LAKE HAVASU CITY, ARIZONA
ADMINISTRATIVE SERVICES DEPARTMENT
◆ PROCUREMENT ◆

INVITATION TO BID
RUNWAY LIGHTS AND SIGNS IMPROVEMENT PROJECT
PROJECT NO. B25-PW-ARP-104015-500657
ADDENDUM NO. 2
APRIL 17, 2025

Attachment A
PRE-BID MEETING MINUTES
FOR
CONSTRUCTION OF
RUNWAY LIGHTS AND SIGNS IMPROVEMENT PROJECT
LAKE HAVASU CITY MUNICIPAL AIRPORT
April 10, 2025

**RUNWAY LIGHTS AND SIGNS
IMPROVEMENT PROJECT**

EA-201
16 of 31

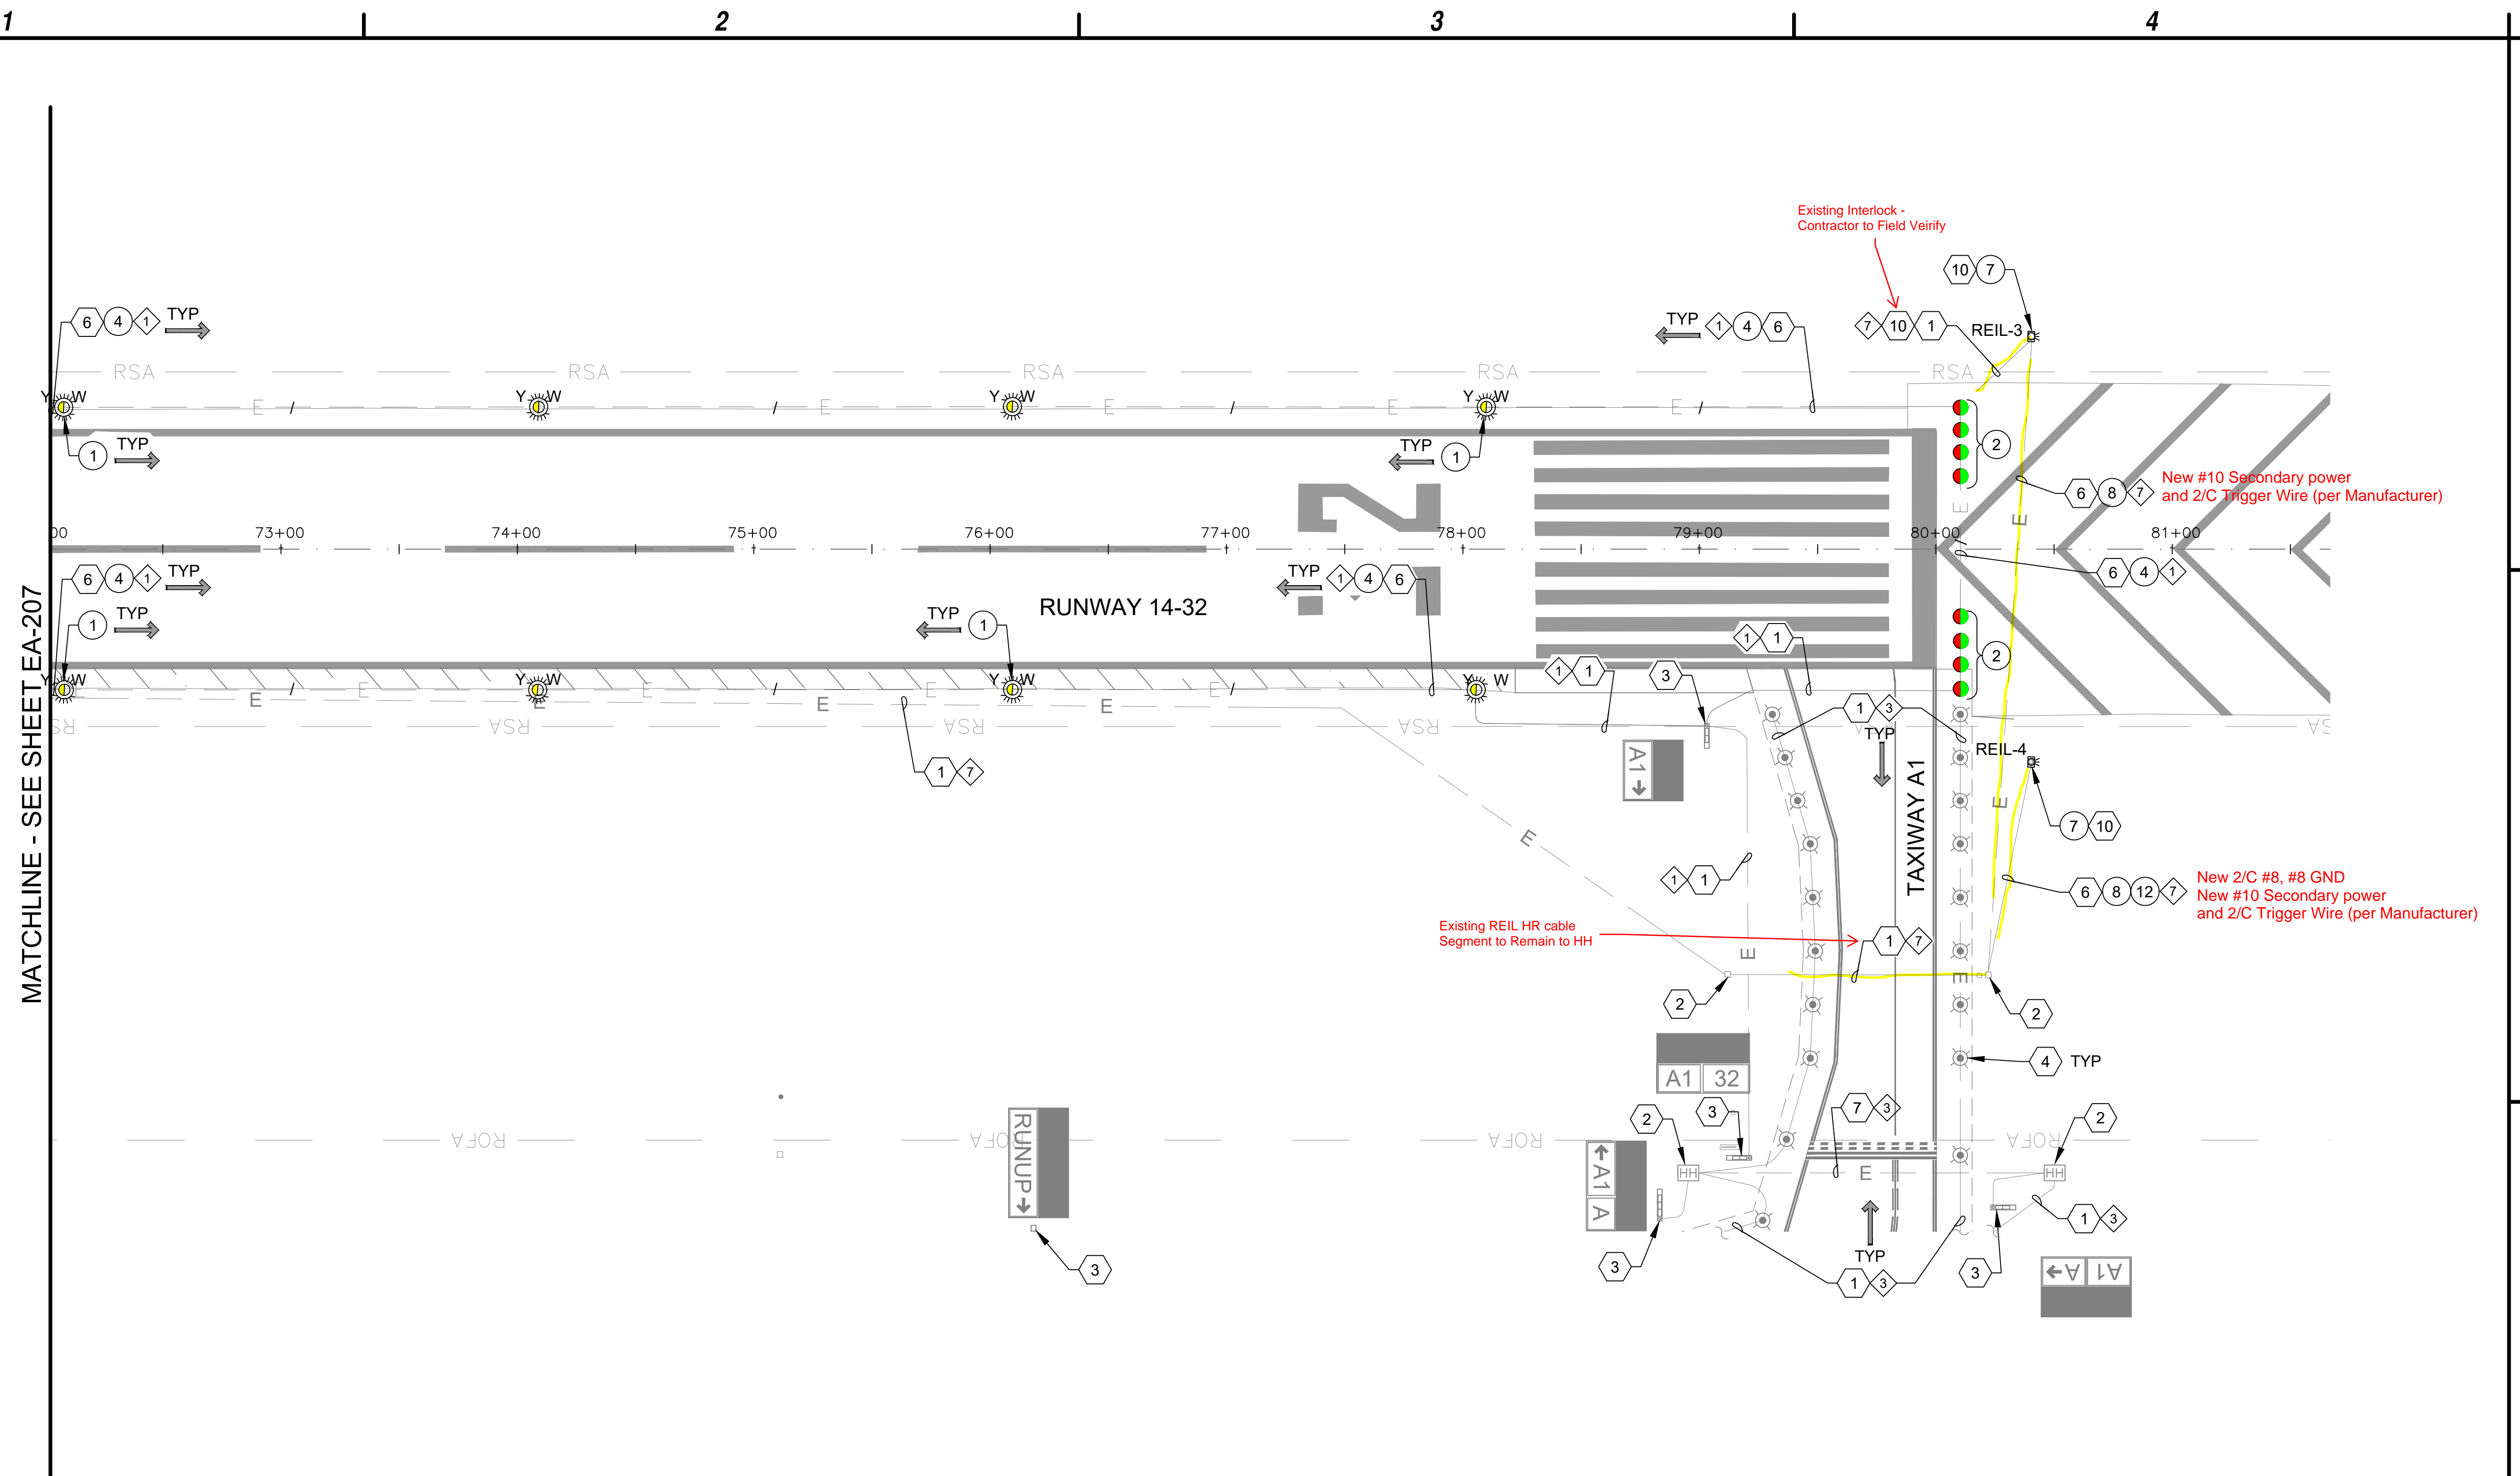
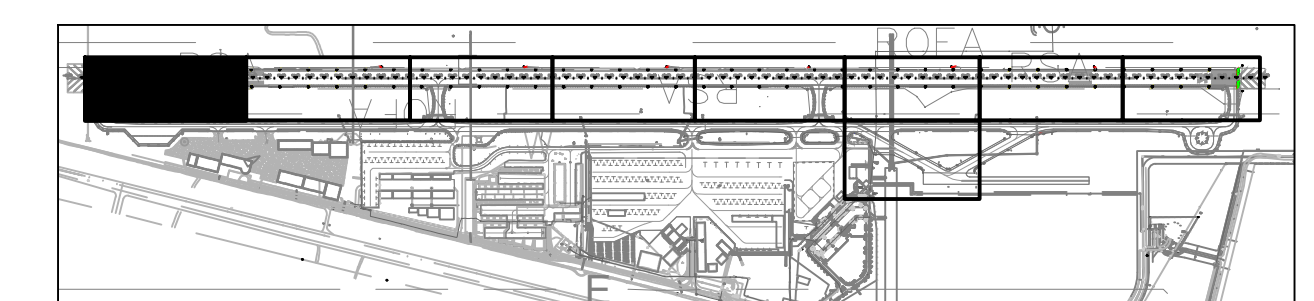
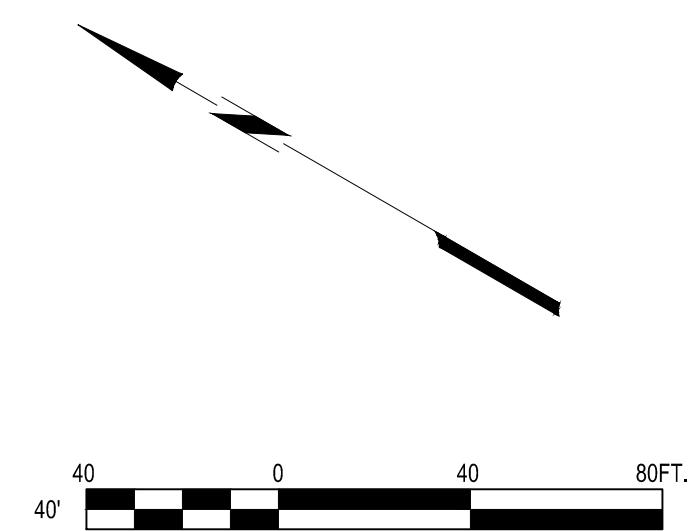
Question 2: Since the existing foundations remain, and there is only one (1) conduit stubbed out of the concrete base at each REIL, how are supply voltage, sync wires, and runway current interlock wires routed?

Question 5: Please label the existing conduits, which carry power, sync signal, and runway current interlock for each REIL.

Answer 2: The existing cables are routed through the conduit from the existing hand holes. Refer to Attachment B plan markups, as-builts and photos.

Answer 5: Every attempt was made to gain access to hand holes and REILs to determine existing conditions. Contractor may have to field verify some items during construction and bid price should reflect additional labor to perform such tasks. Refer to Attachment B plan markups, as-builts and photos.
